Amendments to the Drawings:

REMARKS

In response to the Office Action mailed August 29, 2008, Applicant amended claims 1, 3, 4, 6, 7, 10, 12, 14, 25, and 26 and canceled claims 5, 13, 31. Claims 15-18 and 20-22 are withdrawn. Claims 1-4, 6-12, 14, 19, 23-30 are presented for examination.

Fig. 1

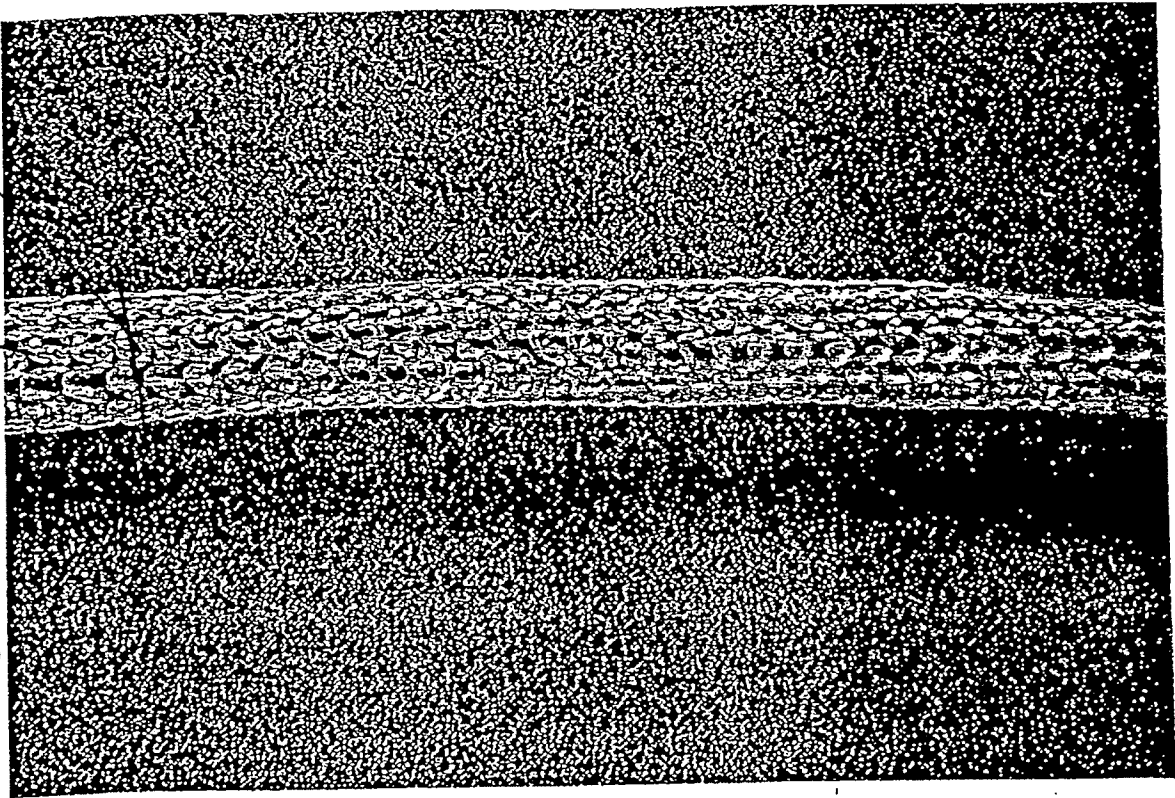
In Figs.1-3, photographs of subassemblies have been replaced with drawings of respective subassemblies.

Photographs
replaced
with
drawings

Fig. 3

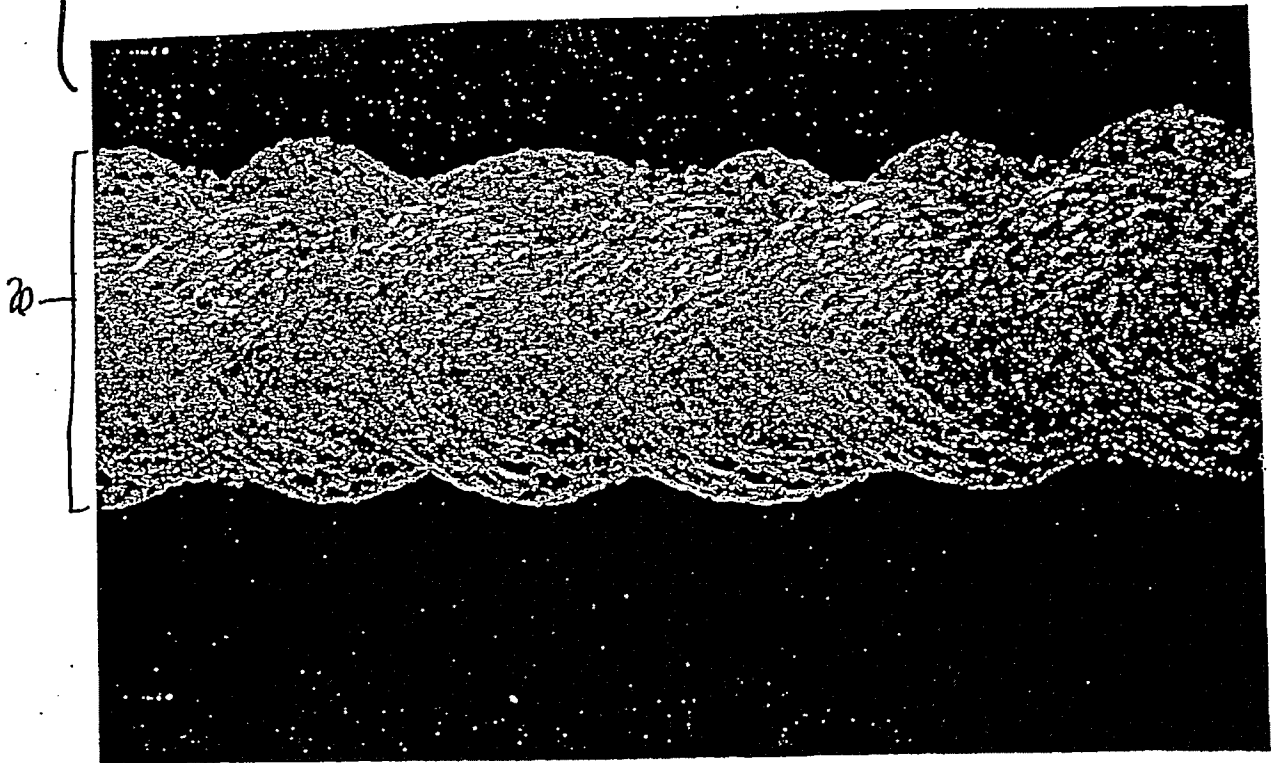
Photographs
replaced
with
drawings

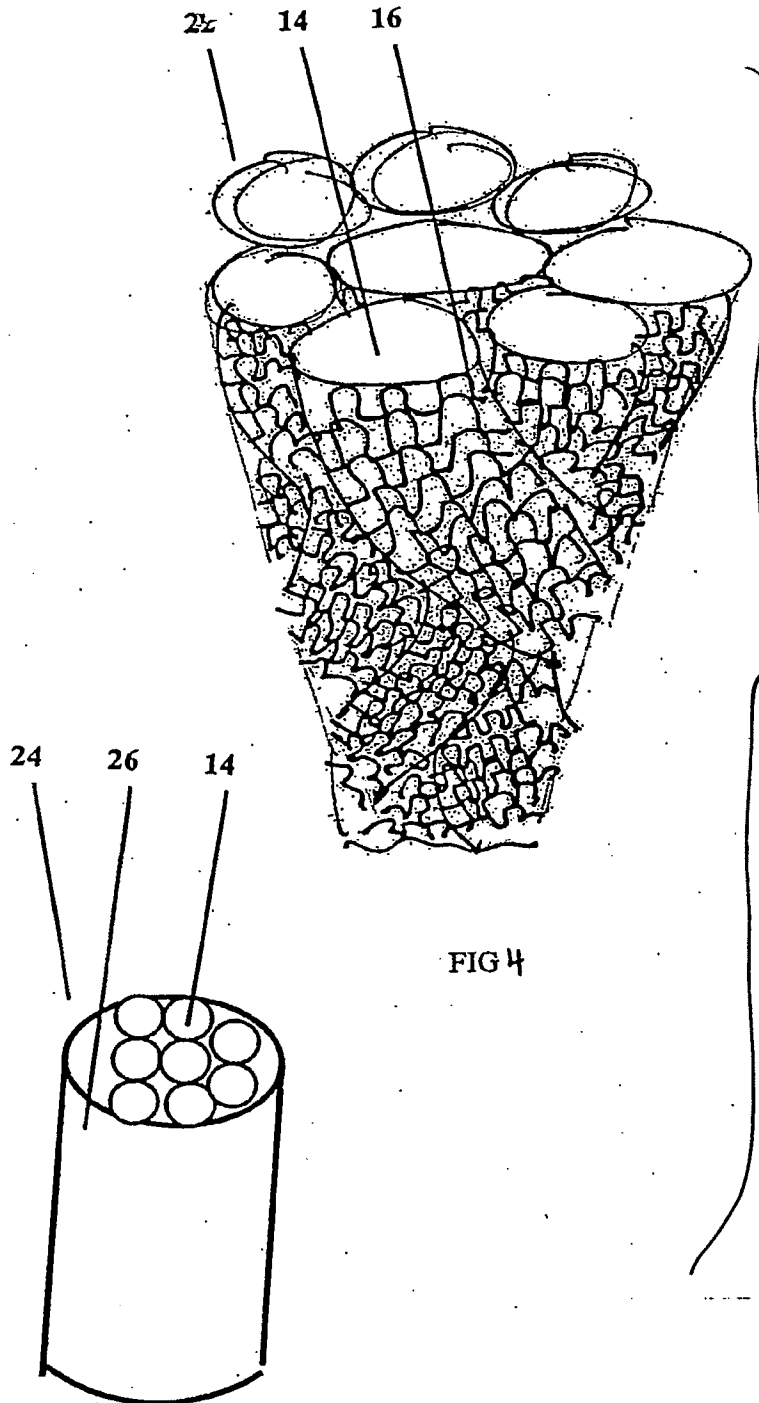
In Fig. 4, 5A-5B, 6C, the drawings have been replaced with drawings including lines, numbers, and letters of uniform thickness and improved legends.

Drawings replaced
with drawings
including lines,
numbers, and letters
of uniform
thickness and
improved legends.

FIG 5C

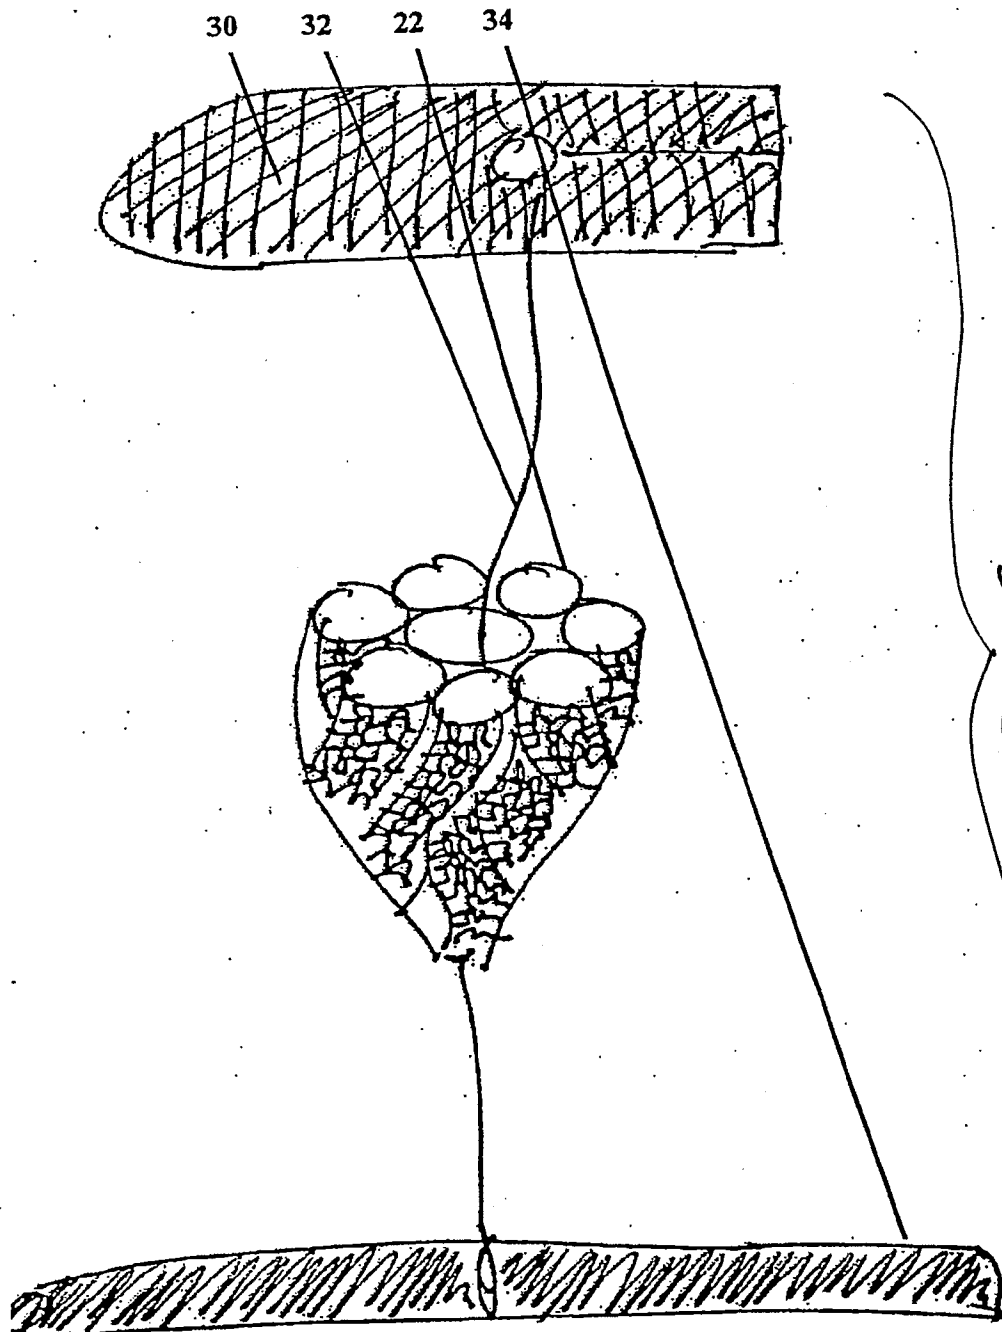
In Fig. 5C, the drawing has been replaced with drawings including lines, numbers, and letters of uniform thickness and improved legends. Element number "28" has been added to Fig. 5B.

Drawings
replaced with
drawings
including lines,
numbers, and
letters of
uniform
thickness
and improved
legends

FIG 6C

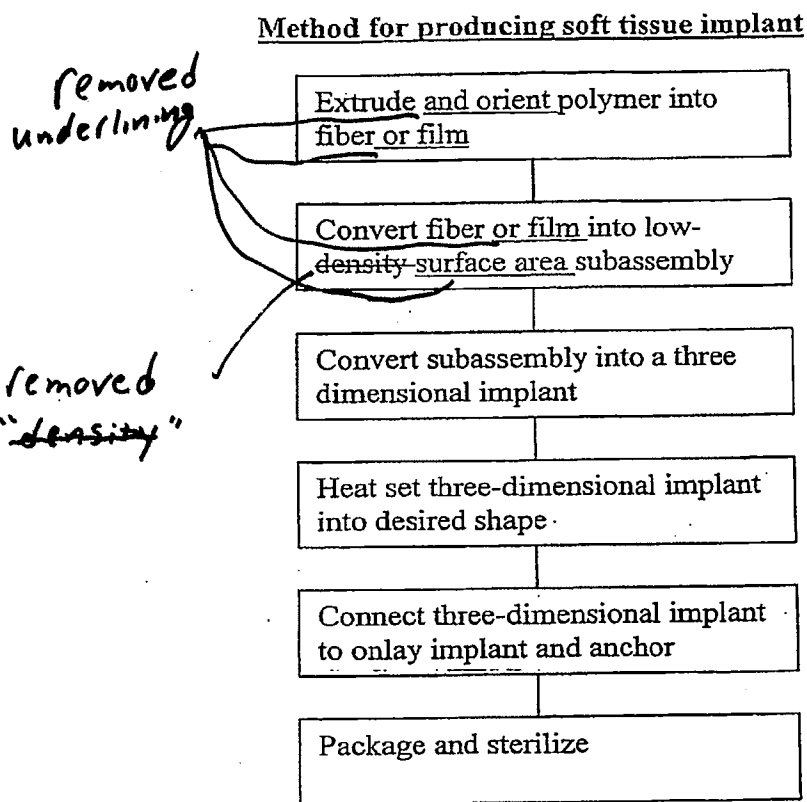
Drawings
replaced with
drawings including
lines, numbers,
and letters of
uniform thickness
and improved
legends.

FIG. 7

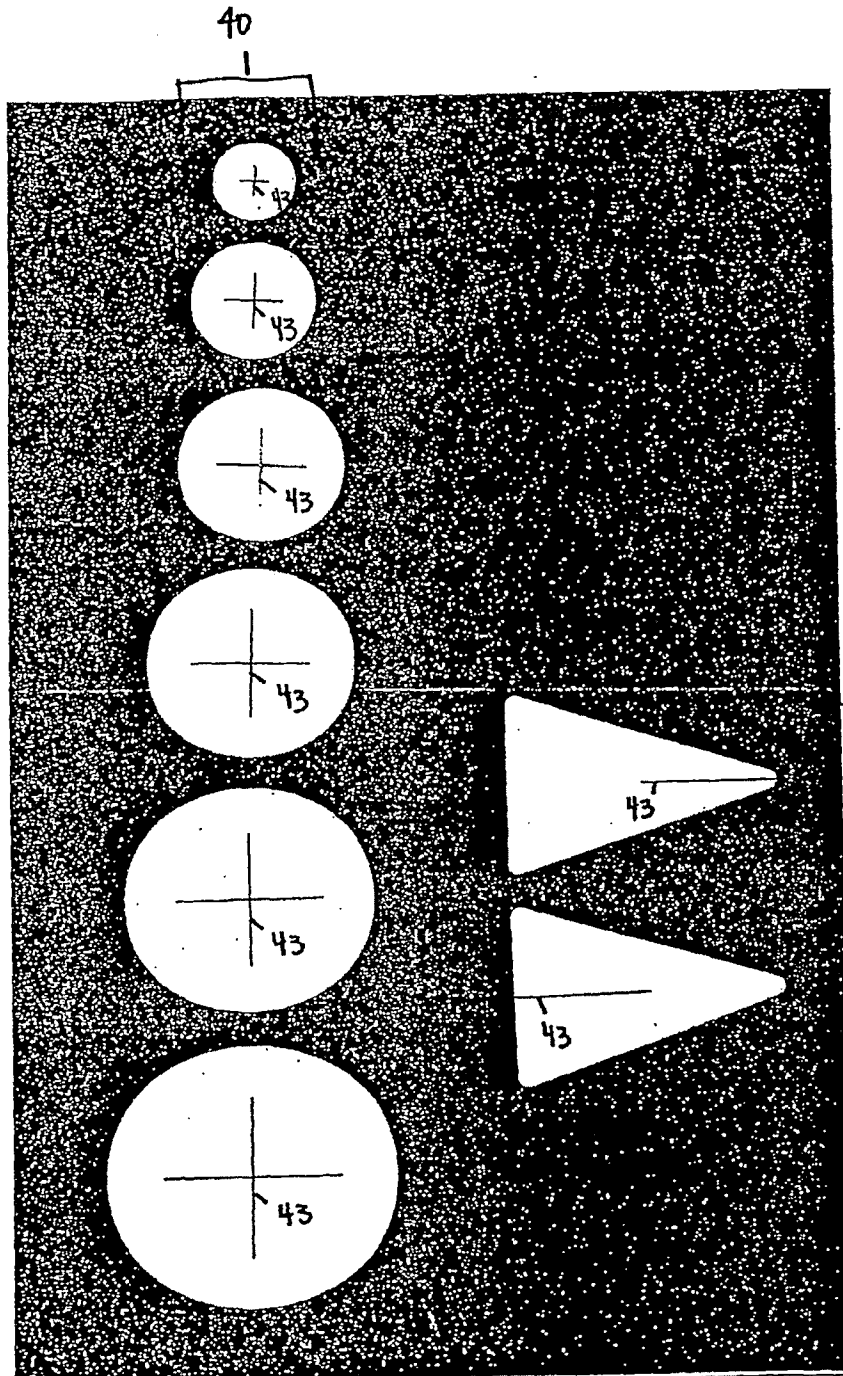
In Fig. 7, the drawing has been replaced with a drawing including lines, numbers, and letters of uniform thickness and the legend has been improved. Underlining has been removed from the words in the figure, and the stricken-through word "~~density~~" was also removed from the figure.

Drawings replaced with drawings including lines, numbers, and letters of uniform thickness and improved legends.

Fig. 9D

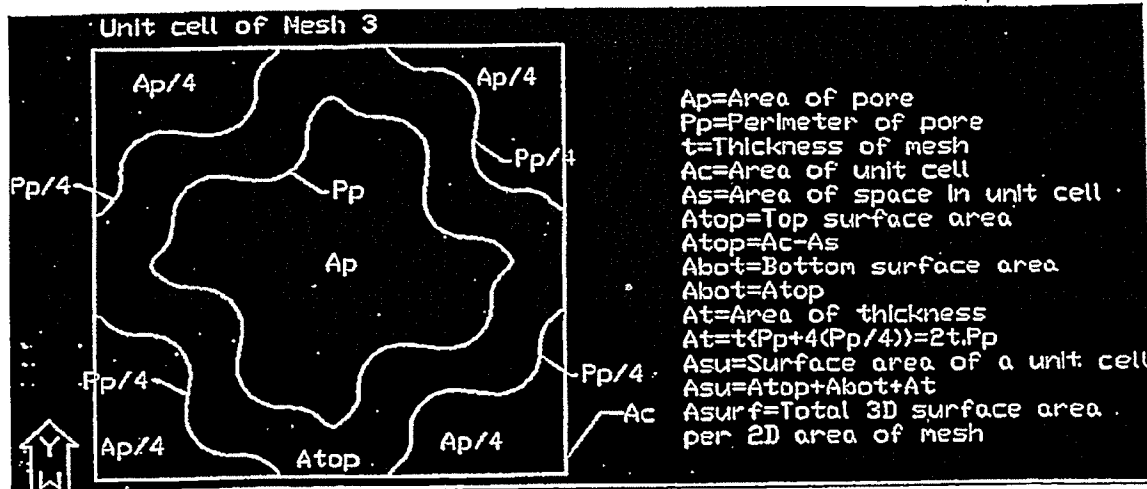
In Fig. 9D, the drawing has been replaced with drawings including lines, numbers, and letters of uniform thickness and the legend has improved. The figure has been amended such that all rows of the table are on the same page and blank rows have been removed.

→ FIG. 9D put on one page.

FIG. 9D
put on
one
page.

Delete
empty
rows
